Access Compliance Report

Public Rights-of-Way

(Curb Ramps)

Intersection ID: N/A	Main Street: LONGSPUR_DR	Cross Street: PAINTED_TRILLIUM_CT	Location: SE
ADA ID: B36550951BF1	Ramp Type: PerpDiag	Initial Pass/Fail: Fail	Overall Compliance: No
Codes/Mitigation Info/Possible Solution		Field Measurements/Component Compliance	
Severity Score: 50

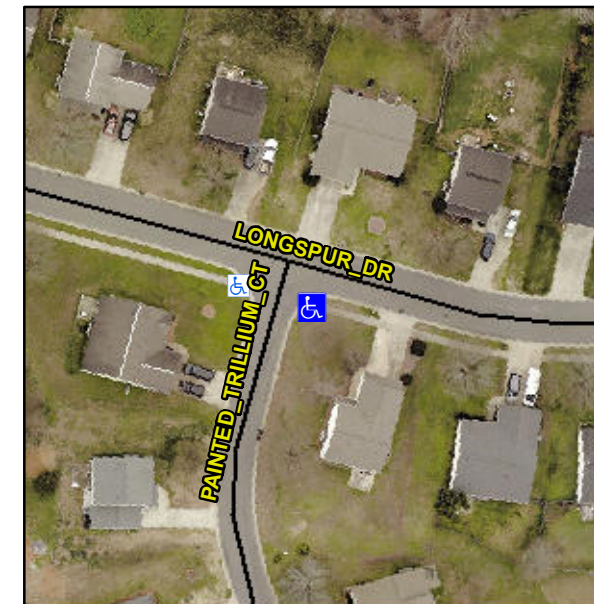
Not Found, R304.2.2, R304.5.3

Compliance	Description	Data	Compliance	Description	Data
N/A	Ramp Length (in)	50.0	No	Ramp Slope (%)	12.2
Yes	Ramp Width (in)	48.0	No	Ramp XSlope (%)	8.9
N/A	Flare Type LT	N/A	N/A	Flare Type RT	N/A
N/A	Flare Slope LT (%)	N/A	N/A	Flare Slope RT (%)	N/A
N/A	Flare Traversable LT?	N/A	N/A	Flare Traversable RT?	N/A
N/A	Landing Length (in)	N/A	N/A	DWS Provided?	N/A
N/A	Landing Width (in)	N/A	N/A	DWS Contrast?	N/A
N/A	Landing Slope (%)	N/A	N/A	DWS Length (in)	N/A
N/A	Landing X Slope (%)	N/A	N/A	DWS Full Width?	N/A
N/A	Landing Curb? (Y/N)	N/A	N/A	DWS Offset (in)	N/A
N/A	Shared Landing?	N/A			
N/A	Gutter Ponding?	N/A	N/A	Gutter Slope (%)	N/A
N/A	Gutter Lip Ht (in)	N/A	N/A	Gutter X Slope (%)	N/A
N/A	Painted X Walk1?	No	N/A	Painted X Walk2?	No
	X Walk 1 Direction	To NW		X Walk 2 Direction	To SW
N/A	X Walk 1 Width (in)	N/A	N/A	X Walk 2 Width (in)	N/A
	X Walk 1 Slope (%)	3.0		X Walk 2 Slope (%)	5.8
	X Walk 1 X Slope (%)	6.3		X Walk 2 X Slope (%)	4.0

Remove & Replace Curb Ramp With Two New Directional Ramps or Equivalent.
